CORRECTIVE PLAN
HORSE FARM ROAD SUBDIVISION
ROUTE 230, TRENTON, HANCOCK COUNTY, MAINE
FOR
JAMES J. BEAUDOIN

FEBRUARY 17, 2003

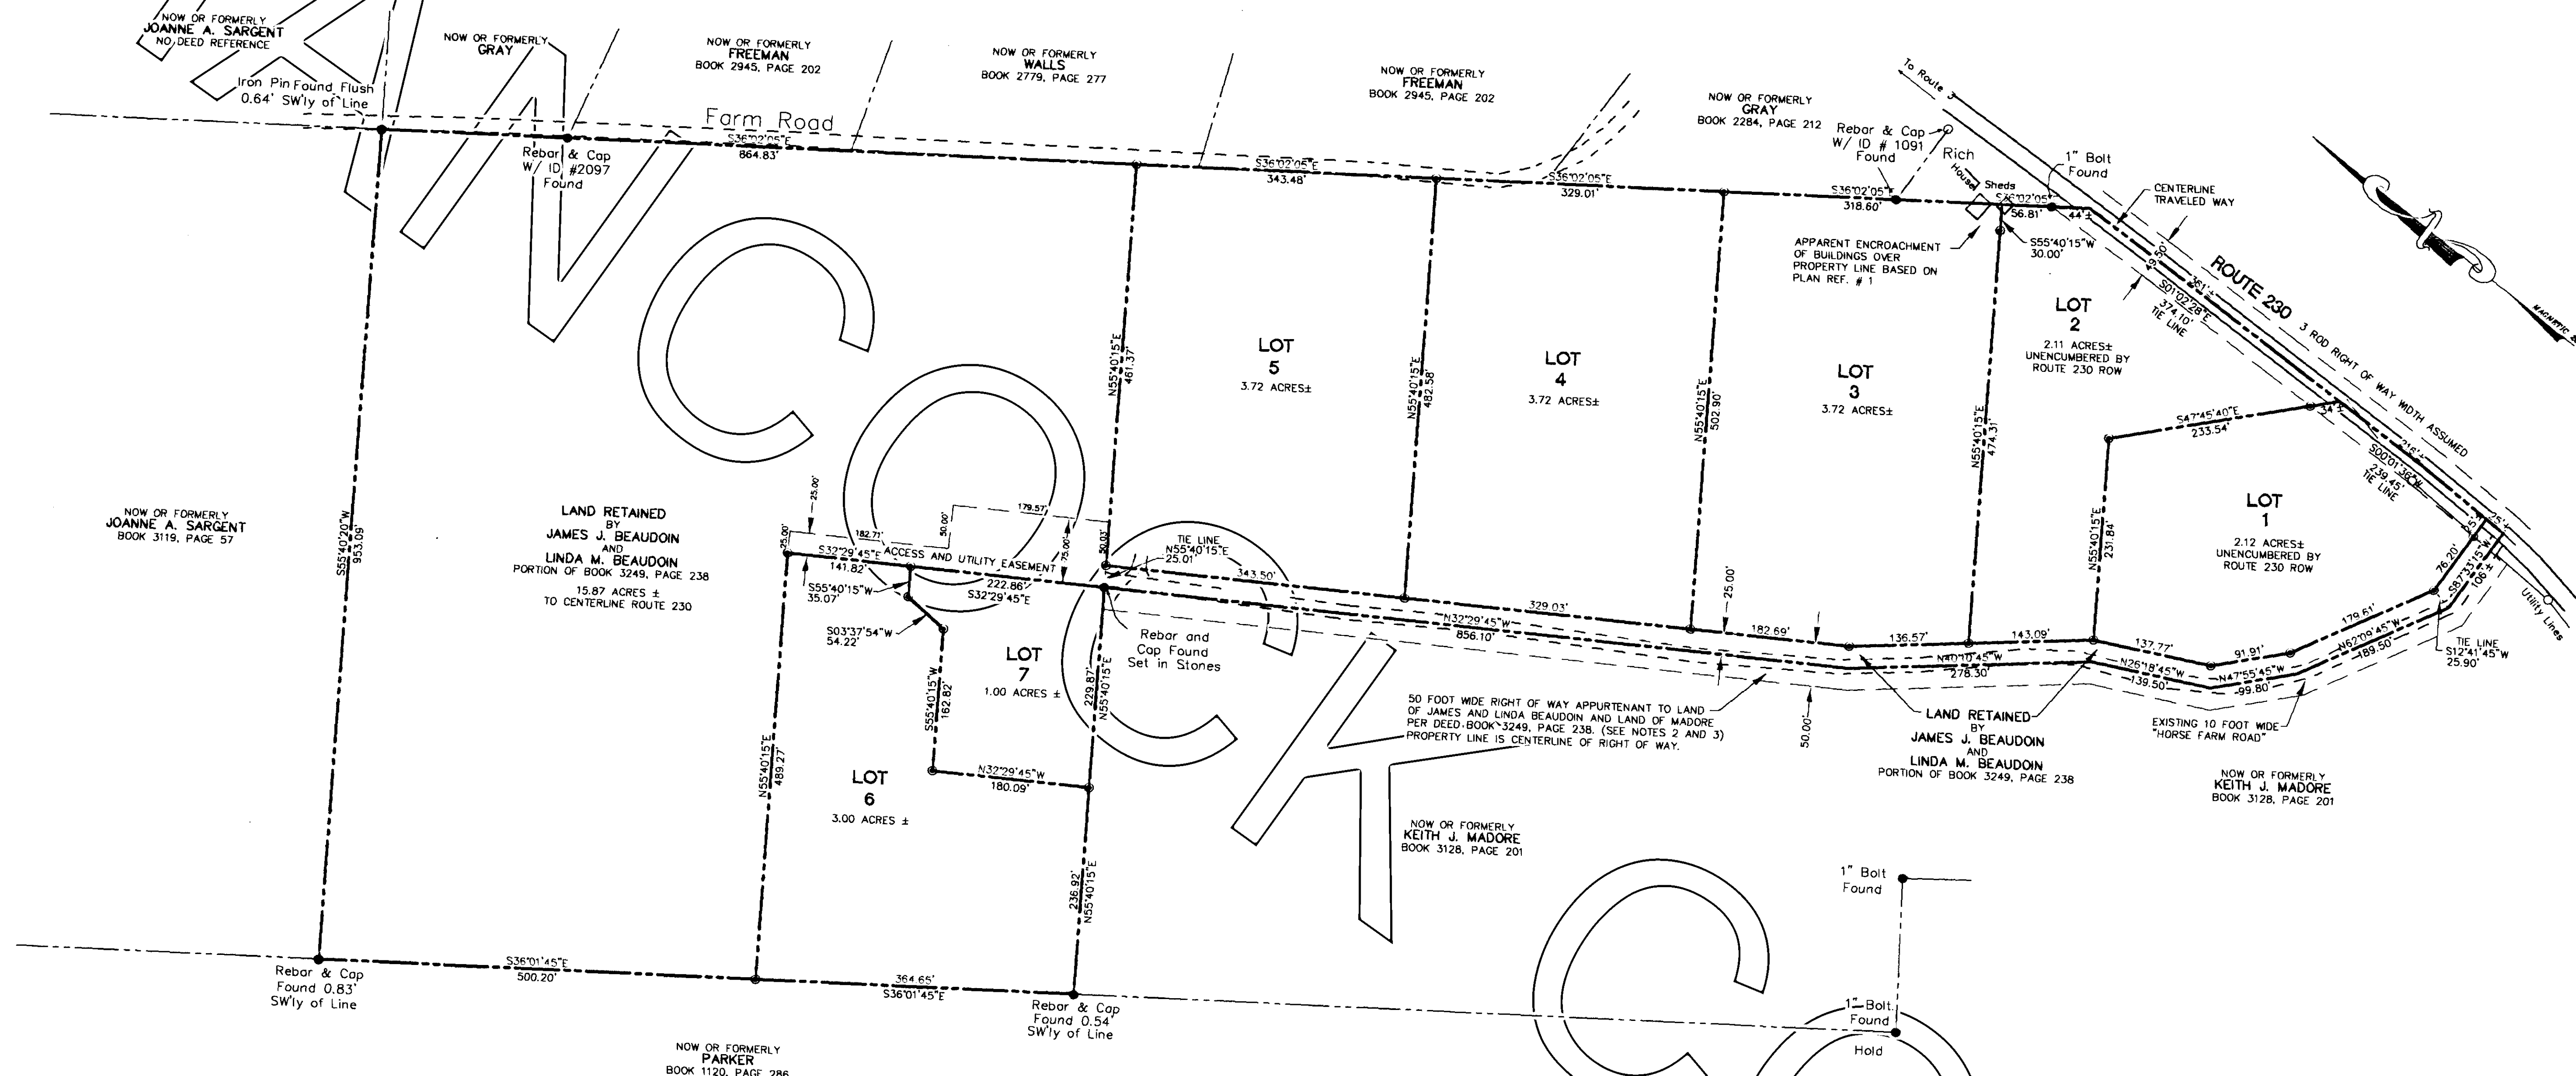
THIS PLAN REVISES AND SUPERSEDES A PLAN ENTITLED "HORSE FARM ROAD SUBDIVISION FOR JAMES BEAUDOIN, OAK POINT ROAD, TRENTON, HANCOCK COUNTY, MAINE", DATED SEPTEMBER 4, 2003, PREPARED BY CES, INC. AND SIGNED BY THE TOWN OF TRENTON PLANNING BOARD ON SEPTEMBER 10, 2003. THIS PLAN CORRECTS DIMENSIONAL ERRORS FOUND ON THE SEPTEMBER 4 PLAN AND CONTAINS NOTES ADDED FOR CLARIFICATION. THE SEPTEMBER 4, 2002 PLAN IS TO SERVE AS THE "SITE PLAN" FOR THIS SUBDIVISION FOR WHICH REFERENCE WILL BE MADE WITH REGARDS TO SITE DETAIL ONLY. THE "CORRECTIVE PLAN" HEREON DATED FEBRUARY 17, 2003 WILL BE UTILIZED FOR ANY CONVEYANCE OF PROPERTY.
